Santa Ana River Wasteload Allocation Model Update

BASIN MONITORING PROGRAM TASK FORCE

November 16, 2017

Response to Comments on TM No. 1

Precipitation Stations Used for WLAM

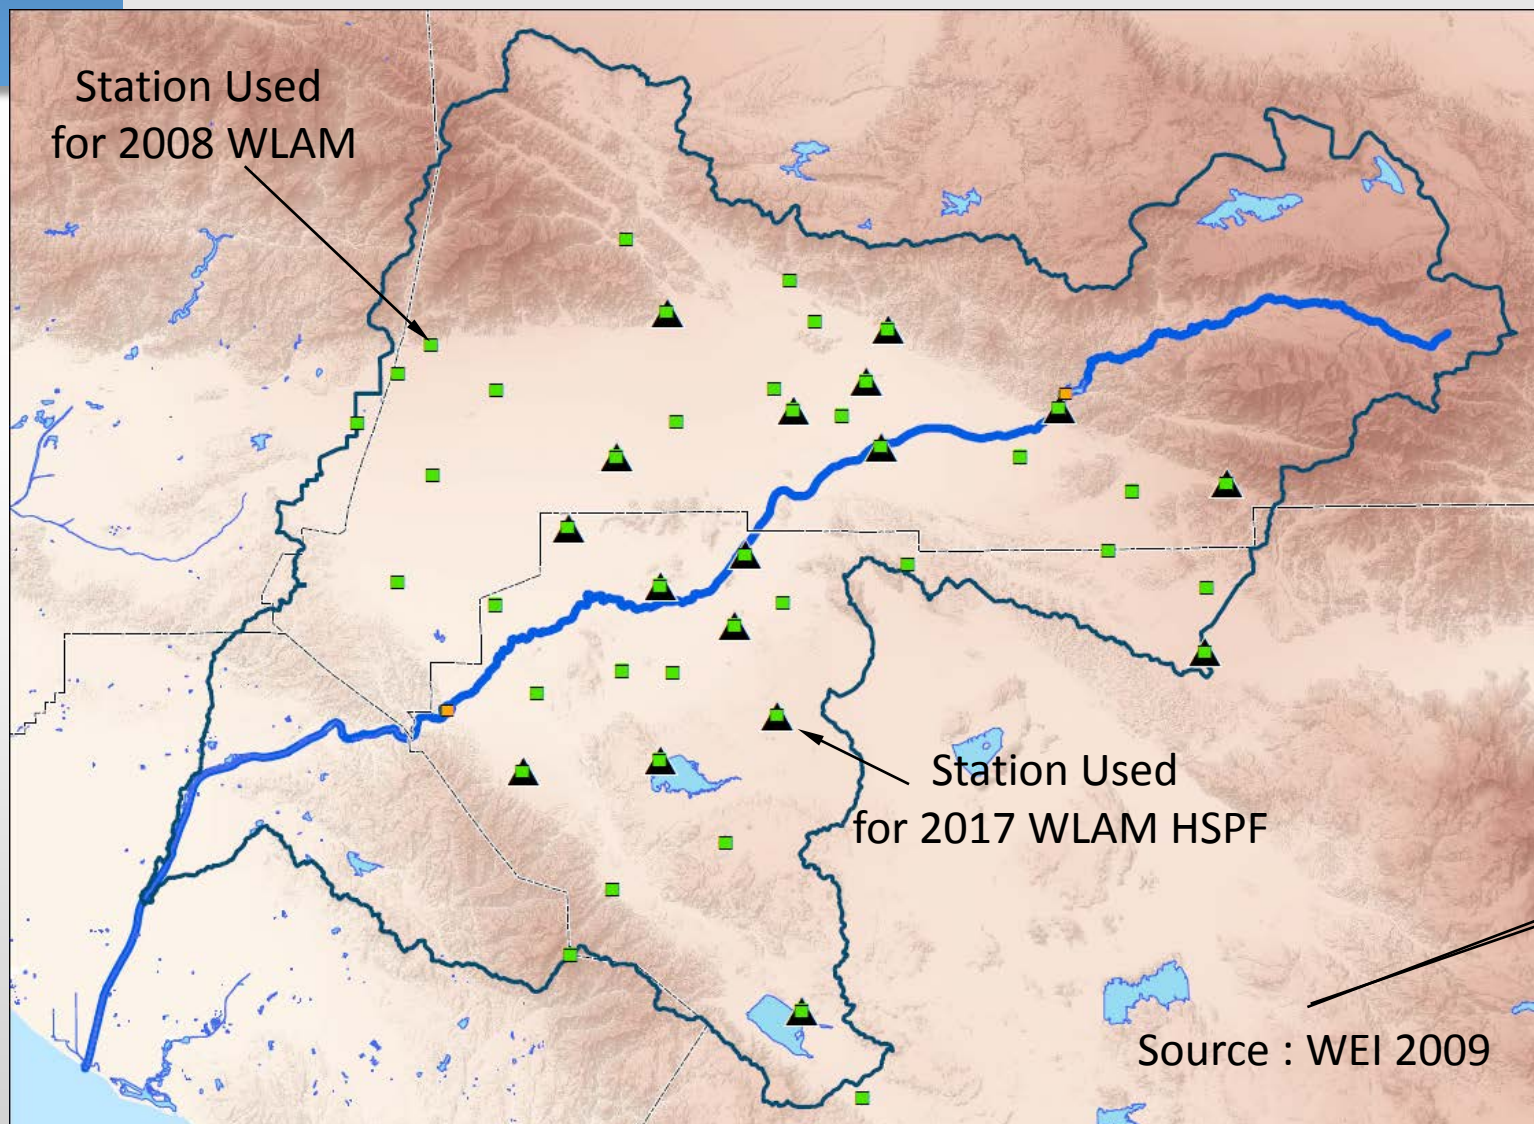
No.	Section	Pg.	Comment	GEOSCIENCE Response
3	2.3	3	<p>Page 3, Section 2.3 and Figure 8. Will reducing the precipitation data coverage from 43 stations to 19 have an impact on the model results? Can you provide a table that summarizes the stations considered, including the names, data provider, the period of record available from the station, if the station was eliminated or is new, and if any data gaps exist for the calibration period of record for the final selected 19 stations. Can you show the spatial location of the 24 stations eliminated from the analysis and call out the five new stations on Figure 8? Were NEXRAD gridded precipitation estimates collected and evaluated and if not, why?</p>	<p>While precipitation data was collected from all 43 stations, only the 19 stations with most complete coverage were used for the model calibration. Reducing the precipitation coverage from 43 stations to 19 will not have an impact on the calibration results.</p> <p>A table will be added summarizing precipitation station details.</p> <p>A comparison of NEXRAD precipitation and the recorded precipitation used for model calibration will be performed as part of Task 11.</p>

Draft TM 2 Figure 46

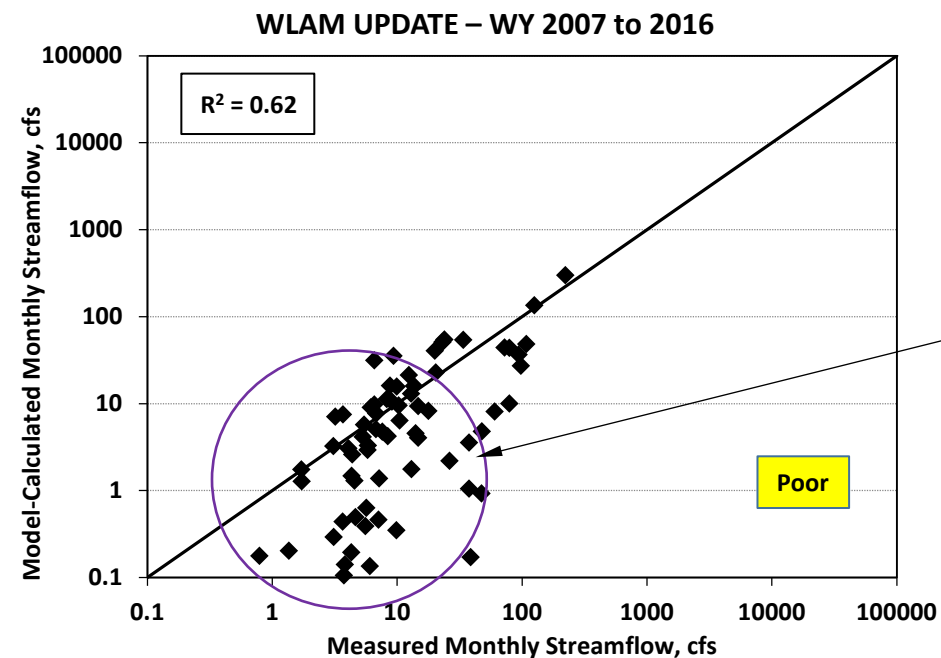
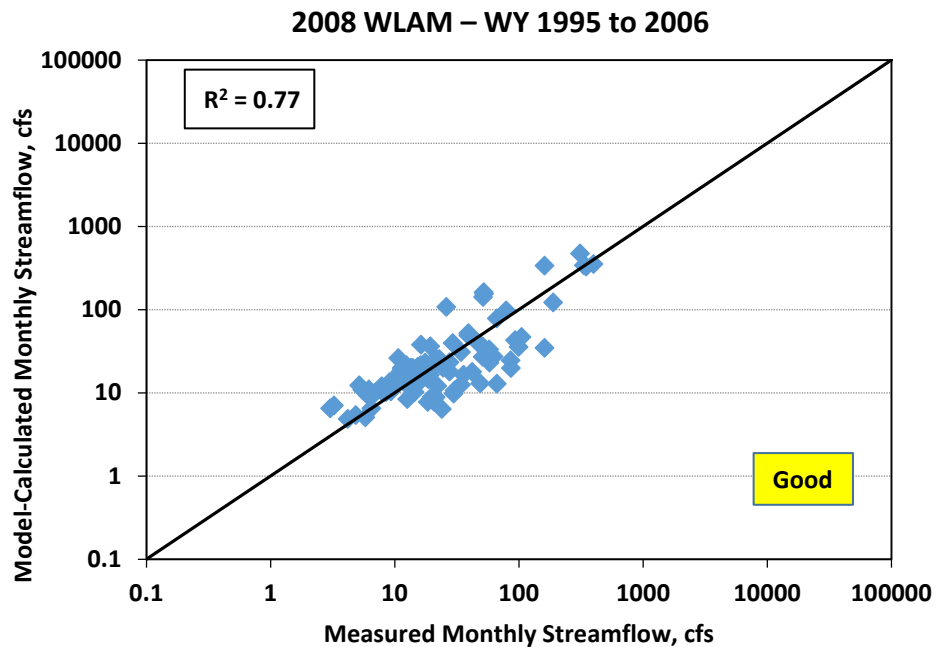
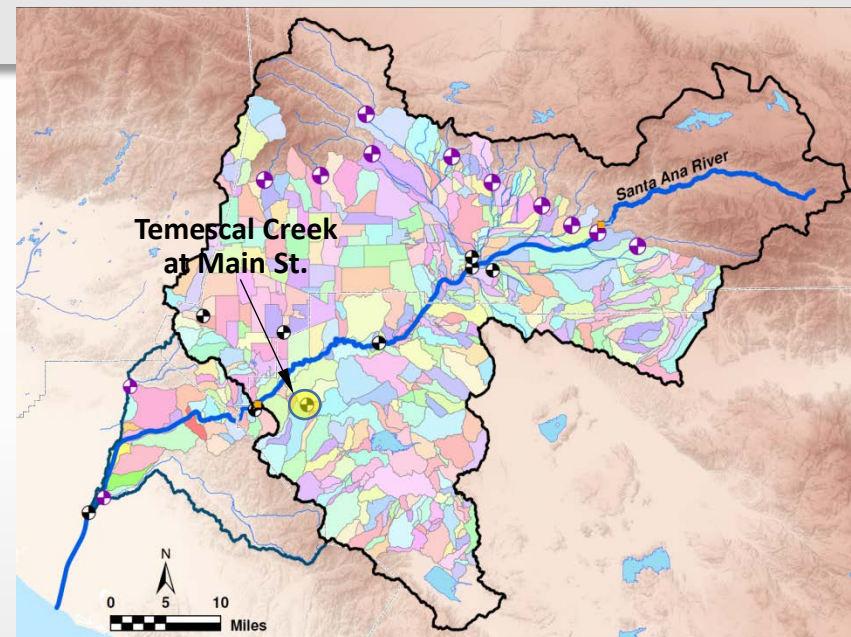
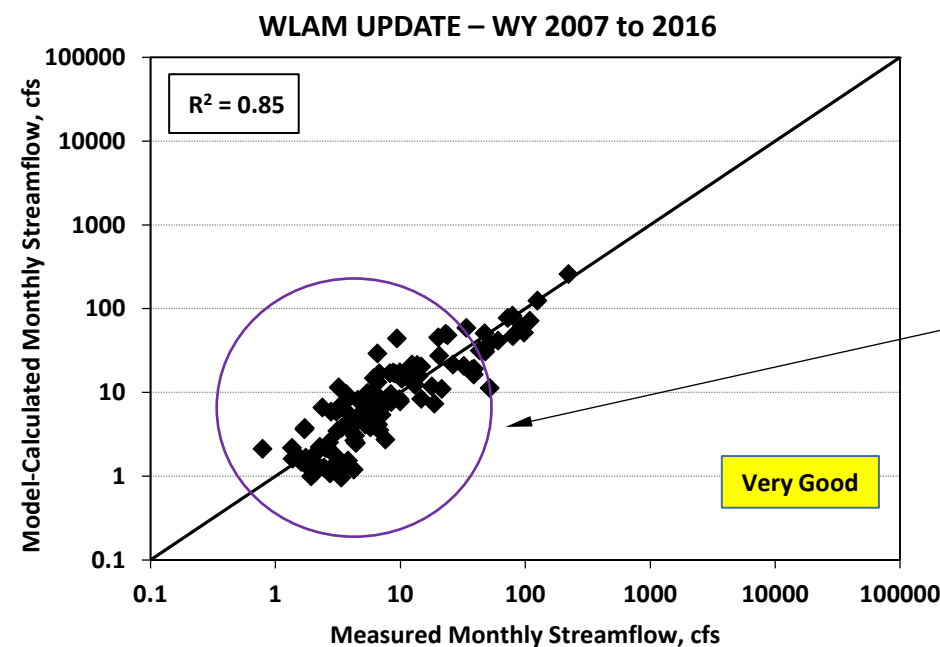
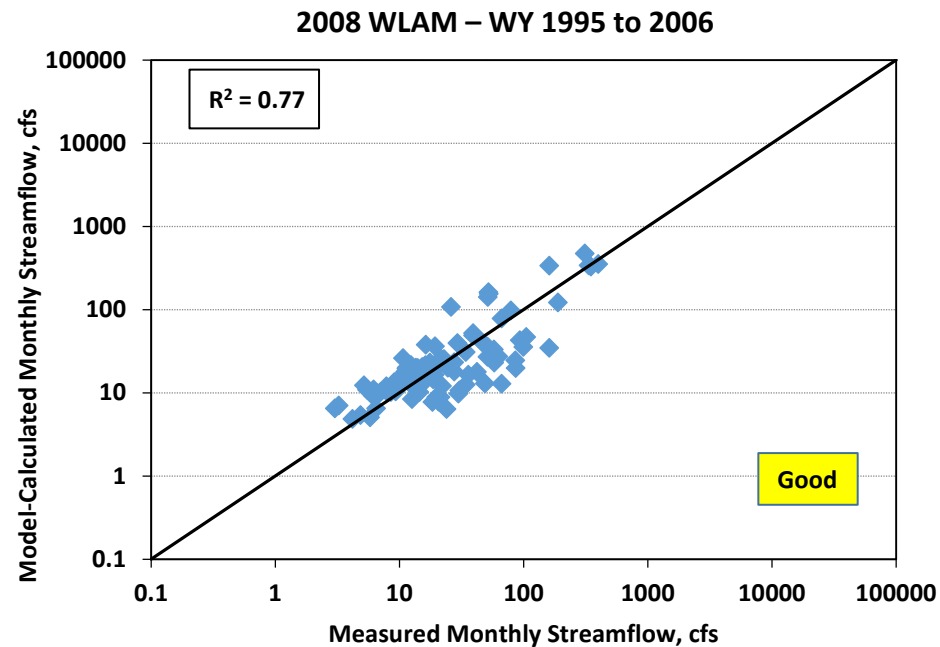
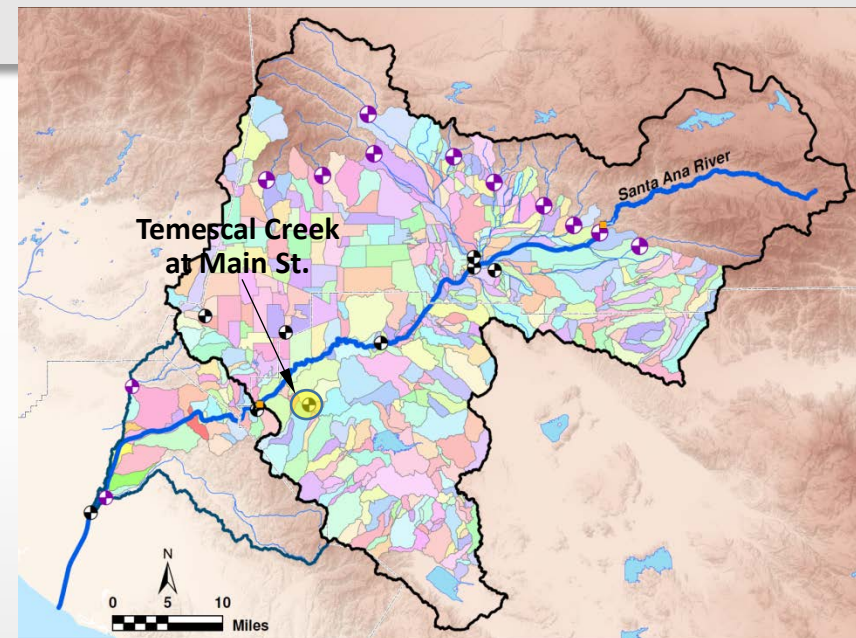
No.	Section	Pg.	Comment	GEOSCIENCE Response
7	3	12, 15	Page 12 & 15. The first sentence states that the calibration is a trial and error process until a "reasonable" match is met between model simulation and actual flows. However, some calibration results indicate a rating of Poor with the new WLAM model. Please explain why a "Poor" R2 level is considered a "reasonable" or "satisfactory" match. Please explain.	The poor calibration for monthly streamflow at Temescal Ck at Main Street has been addressed. The poor calibration for daily streamflow at Santa Ana River at Santa Ana is a product of the modeling process. Flow at this location is largely from the OCWD recharge facilities model, which simulated Prado Dam operations. Actual releases from Prado may be different, which causes a discrepancy between the modeled and observed streamflow at this location. Additional explanation to this effect will be added.

Model underestimation
of base flow with poor
calibration performance

Revised TM 2 Figure 46

Base flow calibration improved with very good calibration performance
